MILITARY SPECIFICATION

CARRIER, COMMAND POST, LIGHT TRACKED:
M577 AND M577A1
PROCESSING FOR STORAGE AND SHIPMENT OF

This amendment forms a part of Military Specification MIL-C-46746D(AT), dated 6 September 1978, and is approved for use by US Army Tank-Automotive Command, Department of the Army, and is available for use by all Departments and Agencies of the Department of Defense.

FIGURE 4A. Screen.

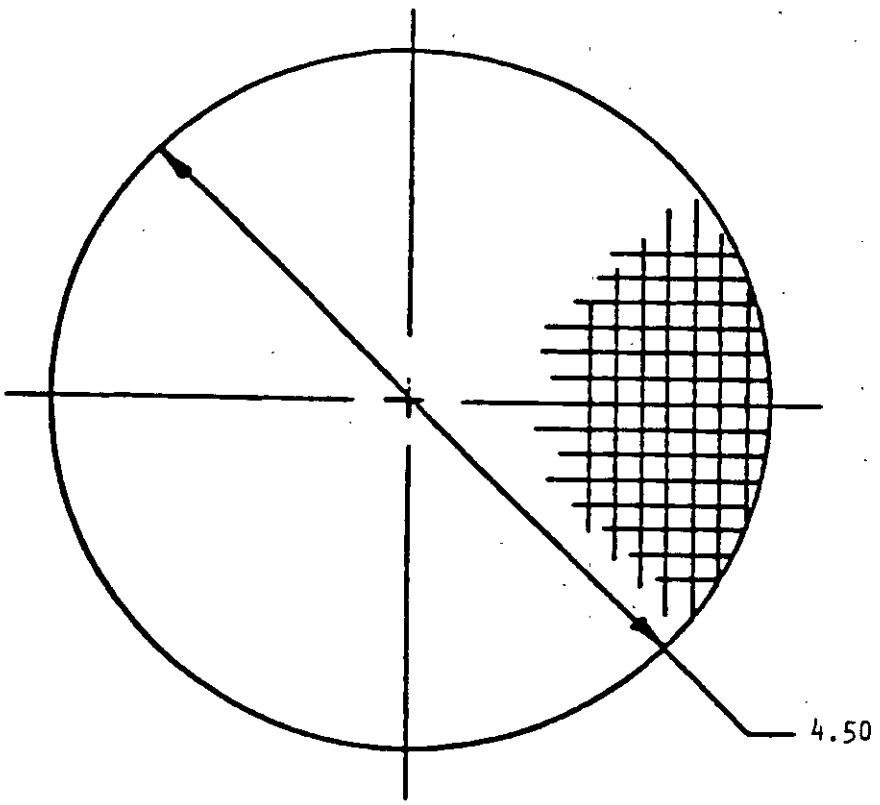
"Engine compartment access plate and drain plugs. Engine compartment access plate and gasket with attaching hardware shall be removed for ventilation. A screen conforming to figure 4 shall be installed in the access plate opening, and secured with four of the existing mounting screws and washers. The two forward drain plugs and the rear bilge drain plug shall be removed for drainage. A screen conforming to figure 4A shall be installed in rear bilge opening and held in place with spring retainer conforming to figure 4B. Bare metal surfaces of drain plugs shall be preserved with compound conforming to grade 4 of MIL-C-16173. Plate, gasket, preserved drain plugs, and four access plate mounting screws and washers shall be packaged as specified in 3.1.9.7. The information "Remove screens, install access plate and gasket front and rear drain plugs before vehicle operation" shall be stenciled on the exterior of the vehicle using white or yellow paint conforming to MIL-P-13983. Stenciling shall be in characters not less than 3/4-inch high."

Add the following page "28-1" entitled "FIGURE 4A. Screen.", after page 28.

FIGURE 4B. Spring retainer.

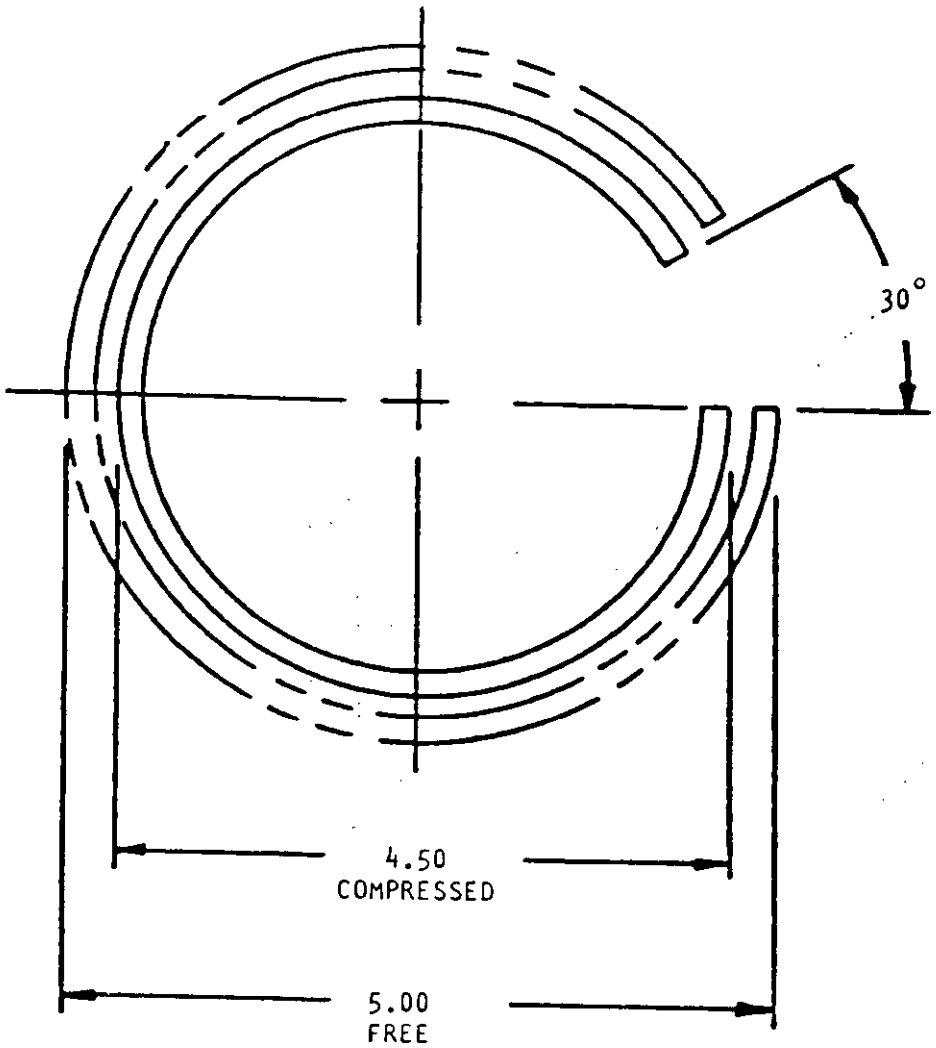
Add the following page "28-2" entitled "FIGURE 4B. Spring Retainer.", after page 28-1.
